Technical Bulletin 218

06.2021

Item	Subject	Model Affected
218.1	Pinpoint Tests - Exhaust Valve	Speed Triple 1200 RS
218.2	Steering Head Bearing Adjustment - Service Tool	Trident
218.3	Pinpoint Test - Coolant Temperature Sensor	Trident
218.4	Triumph Shift Assist	Trident
218.5	Battery Terminal Connections	Trident

Circuit Diagram

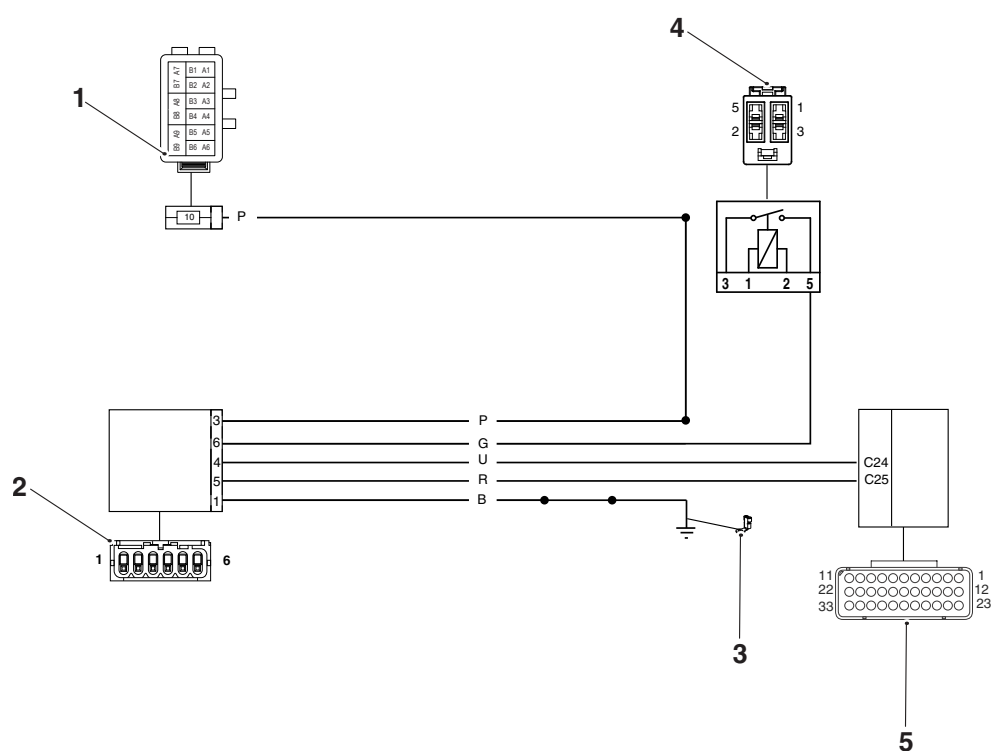
Two pinpoint tests have been released for fault codes P0475, P0476 - Exhaust Valve Actuator and P1081 - CAN Fault - Lost Communication With Exhaust Valve Actuator

P0475, P0476 - Exhaust Valve Actuator

Fault Code	Possible cause	Action
P0475 P0476	Battery voltage. Cable adjustment Exhaust butterfly valve actuator internal fault	Make sure the exhaust butterfly valves actuator connector is secure. View and record the exhaust valve butterfly status using the diagnostic tool. If the diagnostic tool displays the exhaust valve butterfly Status = 01 proceed to pinpoint test 5, otherwise proceed to pinpoint test 1:

Test	Result	Action
1 Check cable and terminal integrity: - Exhaust valve butterfly actuator pin 1 - Exhaust valve butterfly actuator pin 38 - Exhaust valve butterfly actuator pin 4 - Exhaust valve butterfly actuator pin 5 - Exhaust valve butterfly actuator pin 6	OK	Disconnect the exhaust valve butterfly actuator and engine ECM and proceed to test 2
	Faulty	Rectify fault, proceed to test 6
2 Check cable continuity: - Engine ECM pin C24 to exhaust valve butterfly actuator pin 4 - Engine ECM pin C25 to exhaust valve butterfly actuator pin 5 - Exhaust valve butterfly actuator pin 1 to ground - Fuse box 1 fuse 6 to exhaust valve butterfly actuator pin 3 - Ignition Relay Pin 5 to exhaust valve butterfly actuator pin 6	OK	Proceed to test 3
	Faulty	Locate and rectify wiring fault, proceed to test 6
3 - Check fuse box 1 fuse 6 integrity.	OK	Proceed to test 4
	Faulty	Renew fuse, proceed to test 6
4 - Reconnect the harness, run the engine and measure the battery voltage.	OK (13.9V – 14.6V) Faulty	Proceed to test 5 Locate and rectify fault, proceed to test 6

Test		Result	Action
5	Check adjustment of cables is within specification using the diagnostic tool (see Exhaust Butterfly Cables - Check/Adjustment).	OK	Adjust cable tension/span using the diagnostic tool and proceed to test 6
		Faulty	Renew relevant part and proceed to test 6
6	Reconnect harness, clear fault code and run diagnostic software function test to visually verify operation of the exhaust control valve actuator.	OK Fault still present	Action complete - quit test Contact Triumph service

Circuit Diagram

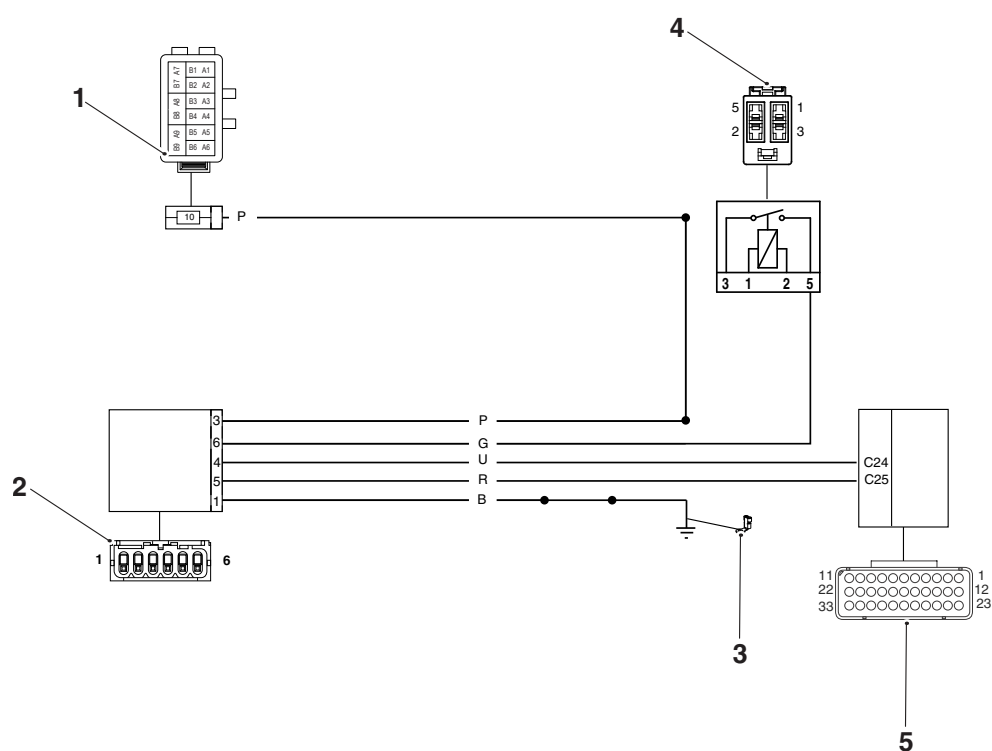
P1081 – CAN Fault - Lost Communication With Exhaust Valve Actuator

Fault Code	Possible cause	Action
P1081	CAN fault - lost communication with Exhaust Valve Actuator	View and note 'freeze-frame' data if available. Make sure the exhaust valve actuator connector is secure. Proceed to pinpoint test 1:

Test	Result	Action
1 Check cable and terminal integrity: - Engine ECM pin C25 - Engine ECM pin C24 - Exhaust valve butterfly actuator pin 1 - Exhaust valve butterfly actuator pin 38 - Exhaust valve butterfly actuator pin 4 - Exhaust valve butterfly actuator pin 5 - Exhaust valve butterfly actuator pin 6	OK	Disconnect the exhaust valve butterfly actuator and engine ECM and proceed to test 2
	Faulty	Rectify fault, proceed to test 6
2 Check cable for short circuit: - Engine ECM pin C25 to ground - Engine ECM pin C24 to ground	OK	Proceed to test 3
	Short circuit	Locate and rectify wiring fault, proceed to test 6
3 Check cable for short circuit: - Exhaust valve butterfly actuator pin 4 to ground - Exhaust valve butterfly actuator pin 5 to ground	OK	Proceed to test 4
	Short circuit	Locate and rectify wiring fault, proceed to test 6
4 Check cable continuity: - Engine ECM pin C24 to exhaust valve butterfly actuator pin 4 - Engine ECM pin C25 to exhaust valve butterfly actuator pin 5 - Exhaust valve butterfly actuator pin 1 to ground - Fuse box 1 fuse 6 to exhaust valve butterfly actuator pin 3 - Ignition Relay Pin 5 to exhaust valve butterfly actuator pin 6	OK	Proceed to test 5

Faulty	Locate and rectify wiring fault, proceed to test 6
5 - Check fuse box 1 fuse 6 integrity.	OK	Proceed to test 6
	Faulty	Renew fuse, proceed to test 6
6 Reconnect harness, clear fault code and run the engine.	OK Fault still present	Action complete - quit test Contact Triumph service

T3880750 - Headstock Service Tool

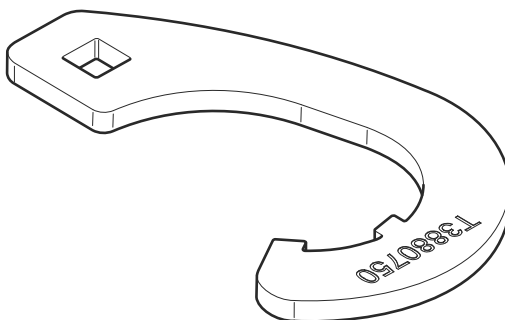
The Service Manual for the above model has been updated with the addition of an extra service tool. The service tool used to hold and tighten the adjuster nut is now T3880750 - Headstock Service Tool. The service tool used to tighten the lock nut remains the same.

1. T3880750 - Headstock Service Tool

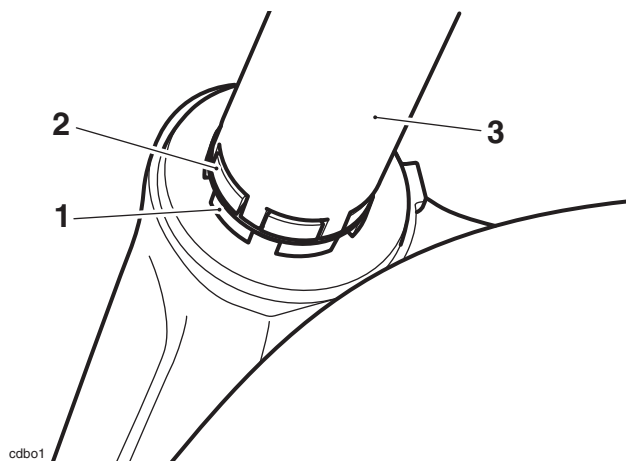
- Keep the torque wrench at 90 degrees to the centre line of service tool T3880750 when you tighten the adjustment nut in the stage that follows. This will apply the correct torque to the adjustment nut.
7. Adjust the bearing free play as follows, using service tool T3880023 and service tool T3880750:
- Remove the lock nut and tab washer using service tool T3880023. Discard the washer.
 - Thoroughly clean the threads on the steering stem.
 - Loosen the adjuster nut using service tool T3880750, then tighten to **40 Nm**. Keep the torque wrench at 90 degrees to the centre line of the tool.
 - Loosen the adjuster nut using service tool T3880750, then retighten to **10 Nm**. Keep the torque wrench at 90 degrees to the centre line of the tool.

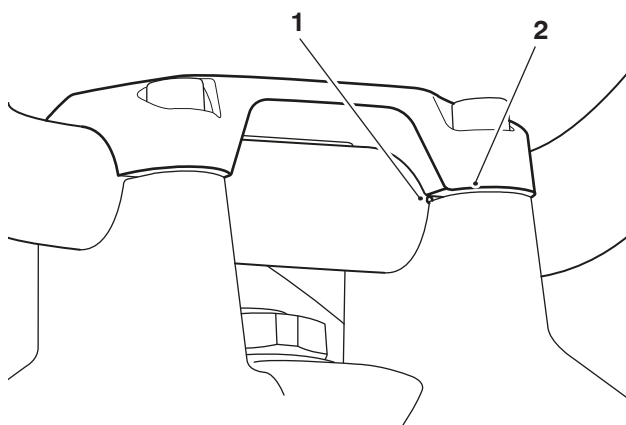
- Hold the adjuster nut in position while tightening the lock nut to **40 Nm**.

Circuit Diagram

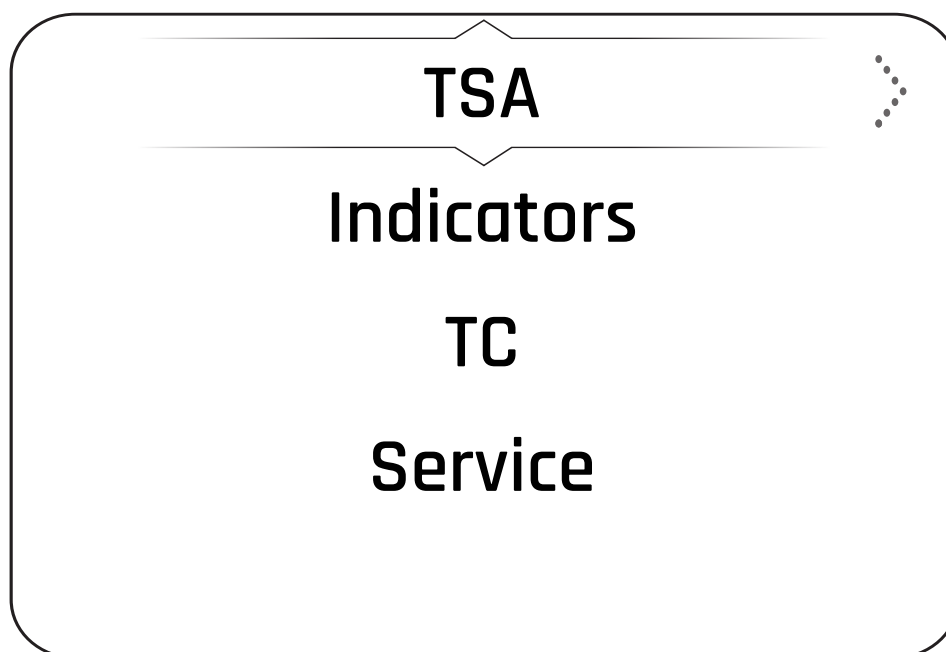
The pinpoint test for the Coolant Temperature Sensor (DTC P0115 and P0117) has been amended for the above model. This information changes the pinpoint test contained in the Fuel System and Engine Management section of the current Service Manual.

Test	Result	Action
1 Check cable and terminal integrity: - Engine ECM pin B20	OK	Proceed to test 2
	Faulty	Rectify fault, proceed to test 6
2 Check resistance value: - Engine ECM pin B20 to ground (Temperature dependent - see below)	OK	Disconnect temperature sensor and proceed to test 6
	Open circuit	Disconnect temperature sensor and proceed to test 3
	Short circuit	Disconnect temperature sensor and proceed to test 4
3 Check cable continuity: - Engine ECM pin B20 to sensor pin 1 - Ground to sensor pin 2	OK	Proceed to test 4
	Open circuit	Locate and rectify wiring fault, proceed to test 6
4 Check cable for short circuit: - Engine ECM pin B20 to ground	OK	Proceed to test 5
	Short circuit	Locate and rectify wiring fault, proceed to test 6
5 Check sensor resistance: - Sensor pin 1 to sensor pin 2 (Temperature dependent - see below)	OK	Proceed to test 6
	Faulty	Renew temperature sensor, proceed to test 6

6 Reconnect harness, clear fault code and run engine to verify fault cleared.	OK	Action complete - quit test
	Fault still present	Contact Triumph service

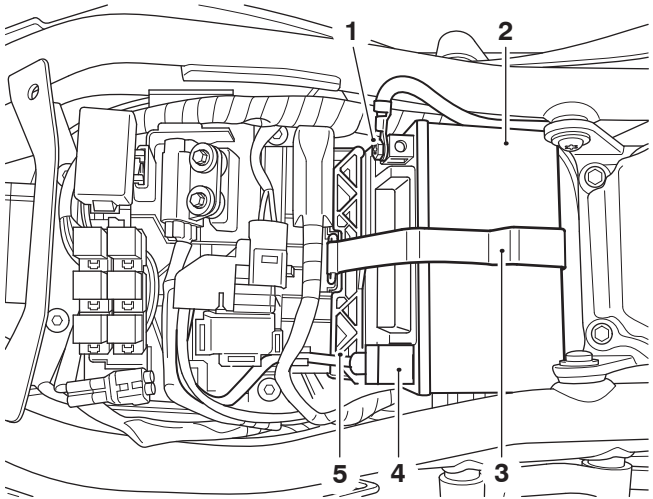
The Service Manual for the above model has been updated to include further information about the installation of the battery and the orientation of the battery leads.

- **The battery positive and negative leads are to be connected to the vertical face of the battery terminals.**
 - **The battery positive lead routes underneath the diagnostic connector cable and clips to the Engine ECM moulding.**
3. Reconnect the battery, positive (red) lead first, routing the positive lead underneath the diagnostic connector cable, and tighten the battery terminals to **4.5 Nm**.

-
4. Make sure the battery positive (red) lead is clipped to the engine ECM tray.
